## Front shock absorbers

Fiat Doblo (ZFA223)

FI132EU

Particularity of the front shock absorbers ref. 16470

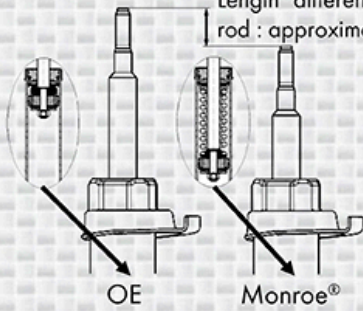
Length difference of the relaxed rod : approximately 70mm

In order to ensure a better quality and better longevity, Monroe® brings improvements in the manufacturing process of these shock absorbers : inner buffer is substituted by a rebound spring.

Because of this improvement, Monroe® shock absorbers have the same technical characteristics, except the length of the rod (relaxed shock absorbers).
